ISLAND AVENUE
109B-F-41

CLIFF ISLAND

Memorandum from Department of Building Inspection, Portland, Maine

Sunset Road, Cliff Island—Amendment to permit 47/2031 for
addition 7' x 12' to side of shed
for and by Norman I. Black

NORMAN I BLACK
CLIFF ISLAND ME.
- Work Shop & Storage -

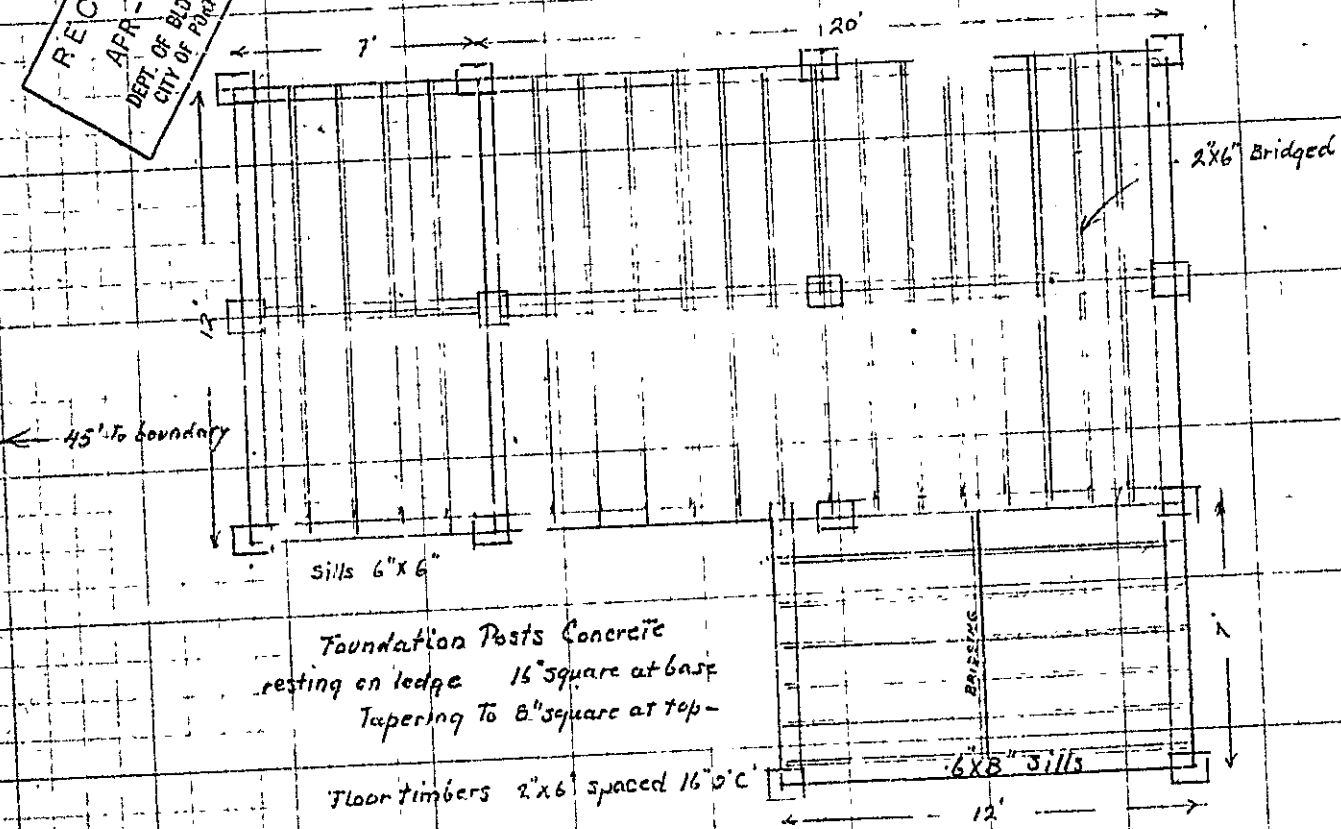
It is noted that the plan filed with the application for amendment states the use of the building to be work shop and storage, while original application named the use as storage of garden tools, etc. Presumably this building is to be used in connection with gardening and farming on the lot on which it is located and as such is an allowable use in the Apartment House Zone where the property is located. However, the use of the building as a shop for the carrying on of a business would not be an allowable use.

PROPOSED
SHED

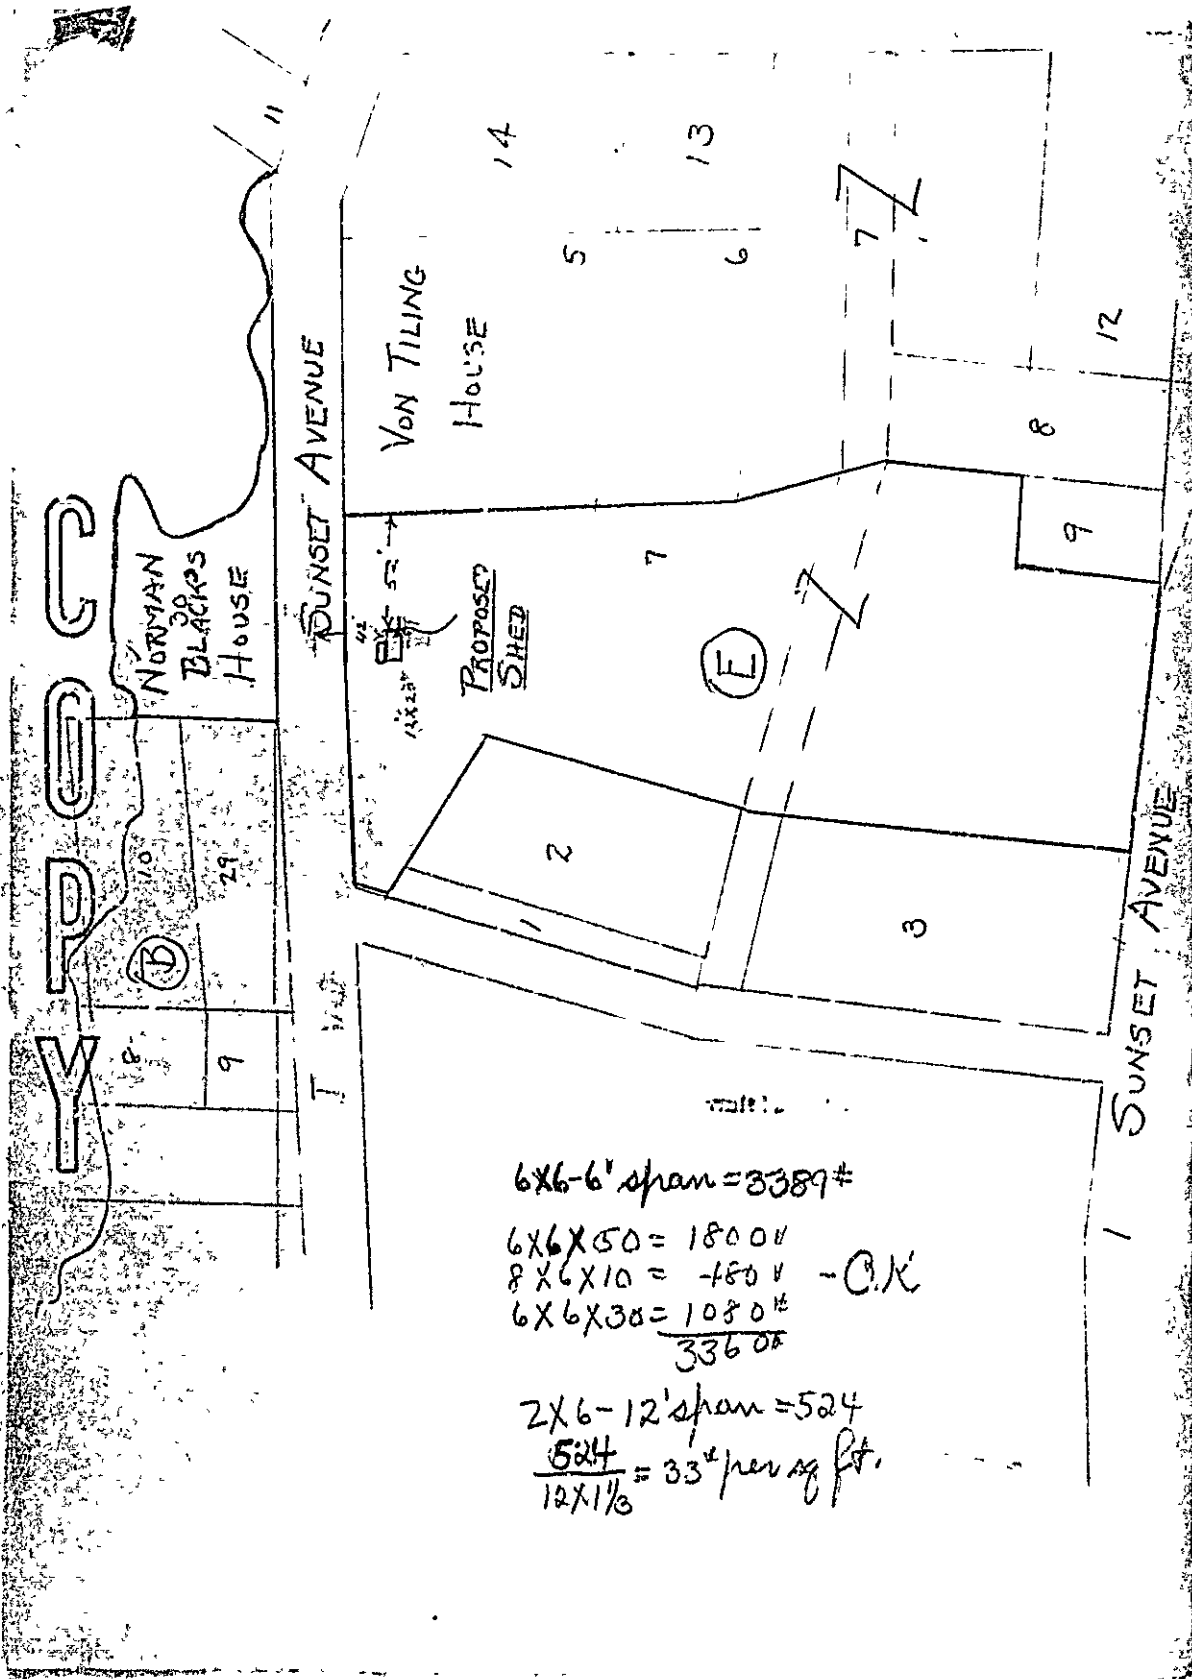
The 2x6 floor joists, on spans of 12', are not very stout, but we shall not object to it--however, no less than 1x3 bridging should be used in the center of each floor joist span and since the building is already built, probably solid bridging will be necessary, which would consist of pieces of 2x6 cut in solid between the floor joists.

The original application showed the concrete piers to be spaced 6' from center to center, using a 6x6 sill. The amendment calls for 10-foot spacing of piers and a 6x8 sill. Presumably the sill would be set with the 3-inch dimension upright, but even so would figure out to be substantially overloaded in case considerable material were in the shed and a heavy snowfall occurred leaving considerable snow on the roof which is quite flat. We shall not object to this arrangement if you want it that way, but the building could be made much more substantial either by placing the piers under sills which support the floor joists on shorter spans or running a center girder through under the floor.
